Bid #18-1963 Bleachers for Sullivan Middle School

Addendum #1: Question and Answers

April 30, 2019

**SULLIVAN MIDDLE
LANGUAGE IMMERSION ACADEMY
BLEACHER PAD ADDITION**
ROCK HILL, SOUTH CAROLINA

SITE PLAN

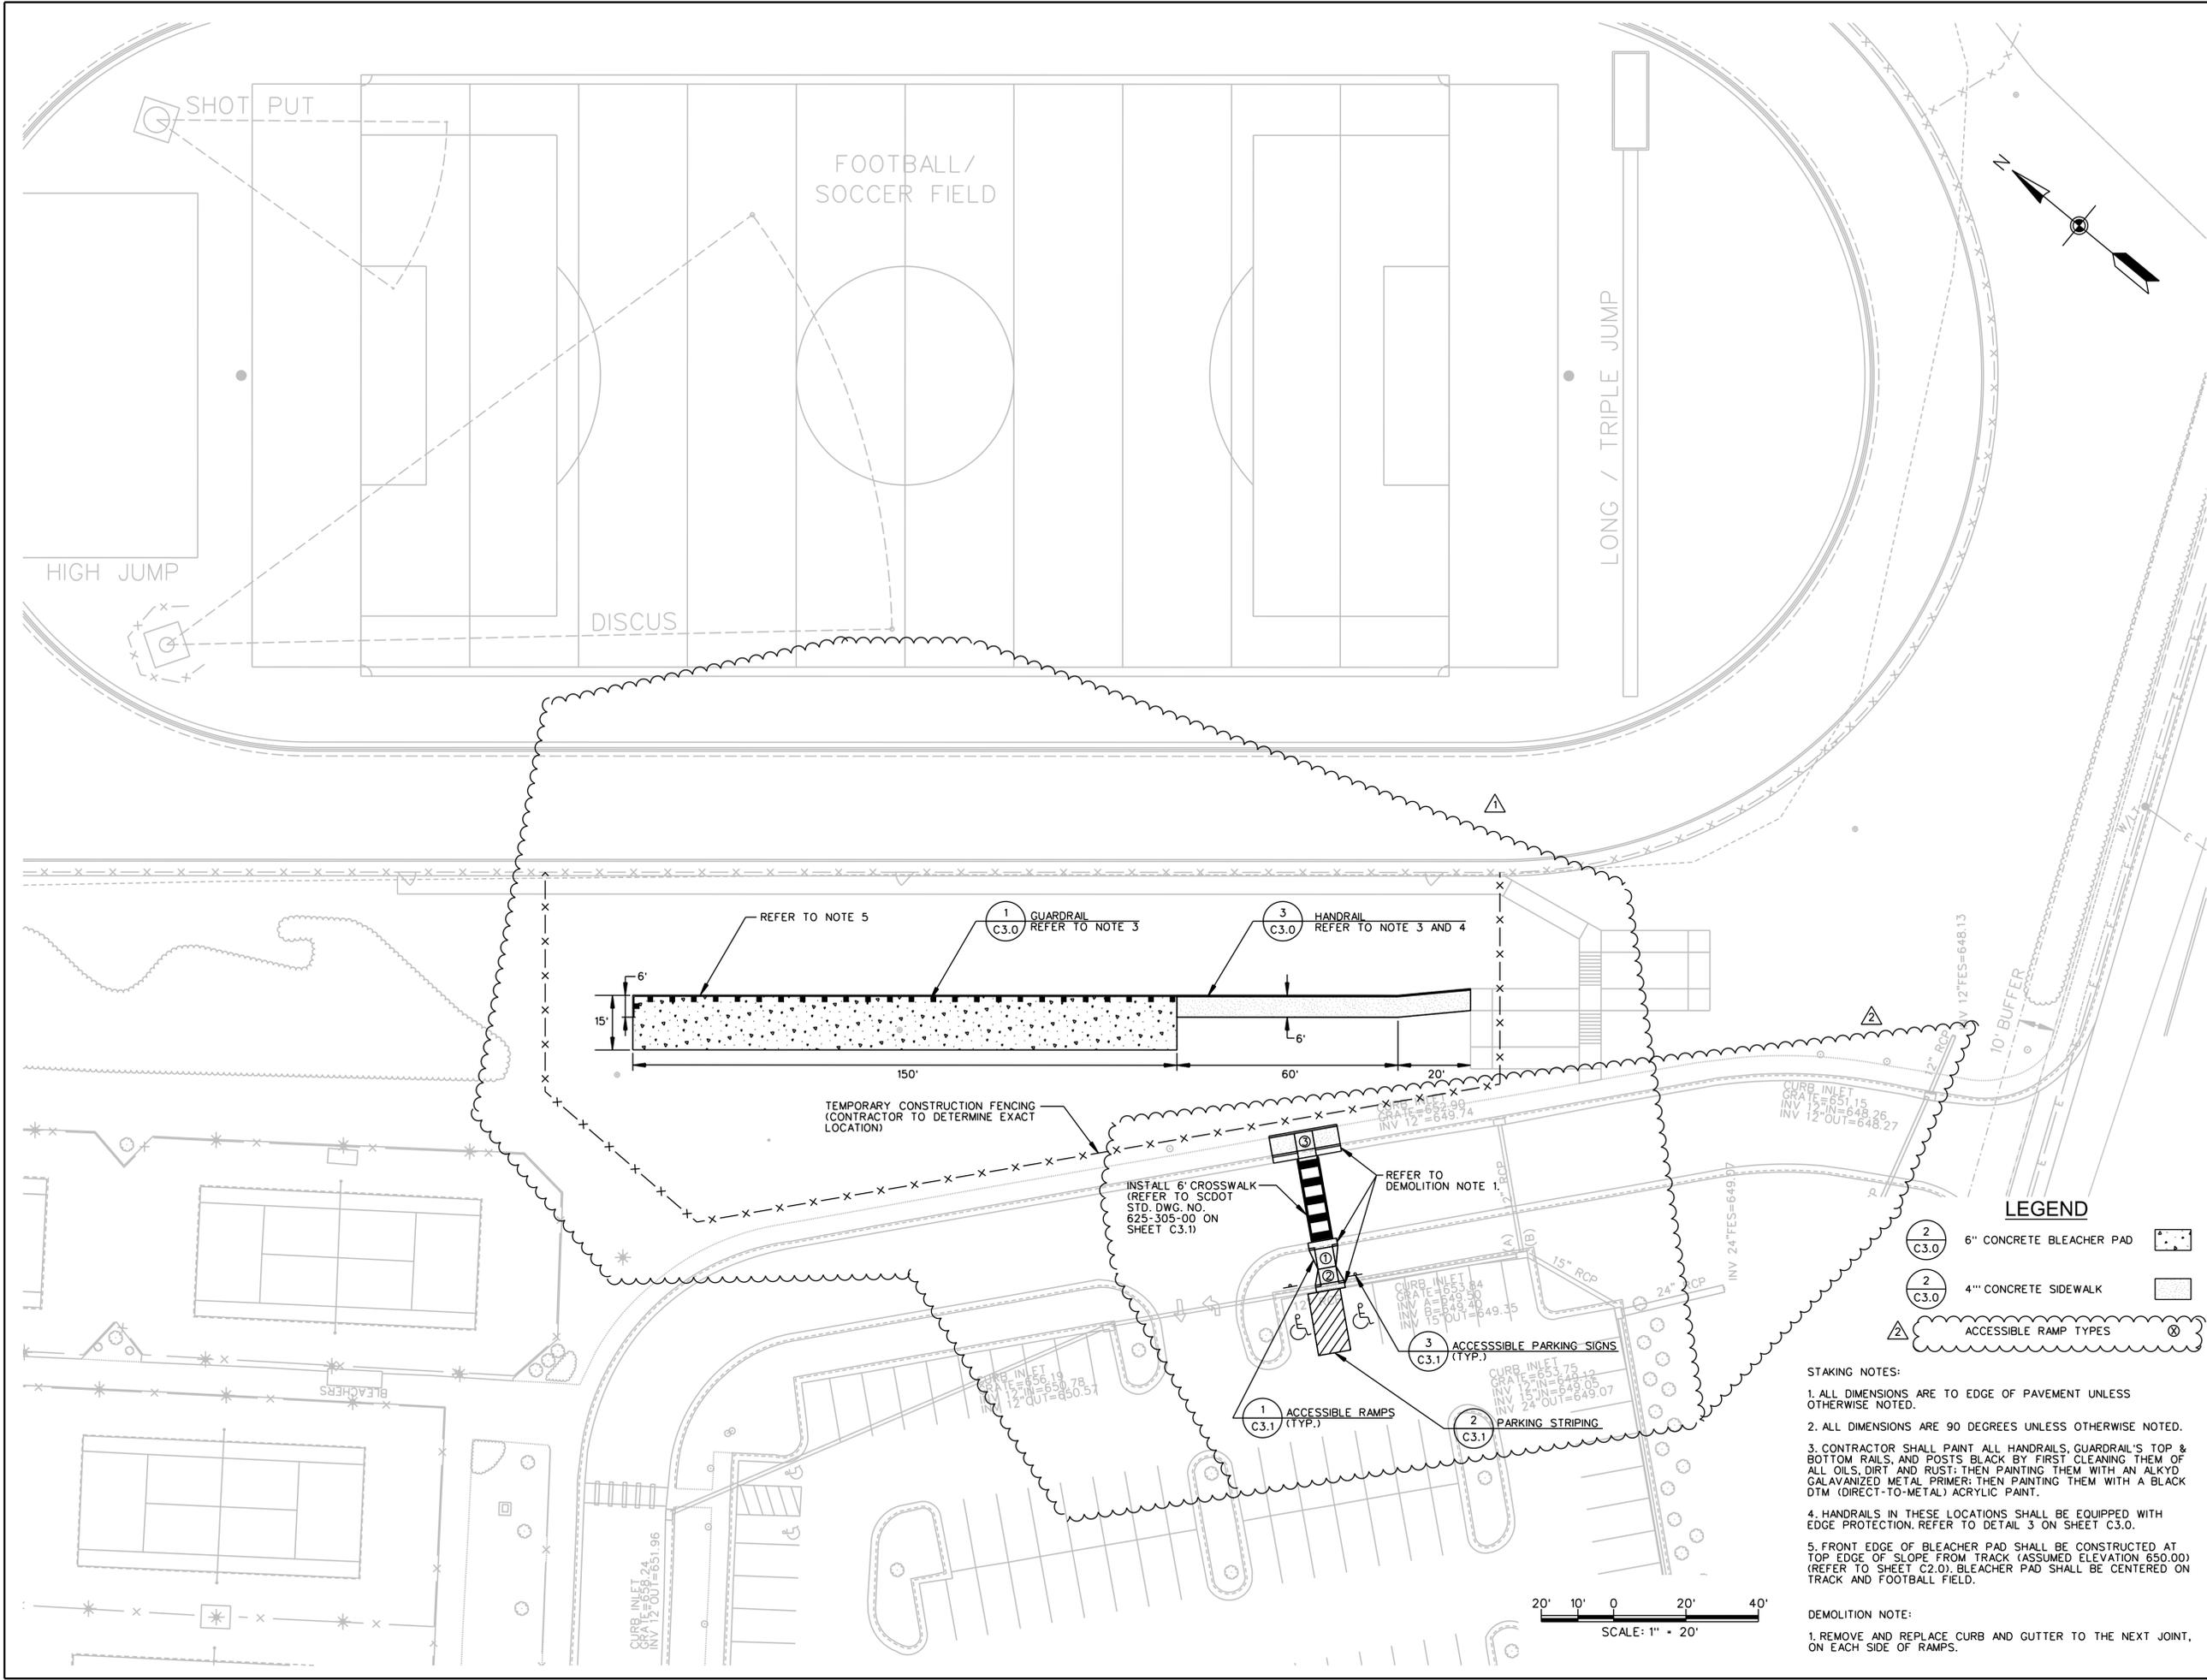
1. What size is the concrete pad for the bleachers?
150' x 15'
2. Where is the pad located?
Please see the attached drawing.
3. Is the concrete slab to be included in the bid price for the Bleachers?
No, the concrete pad has already been poured.
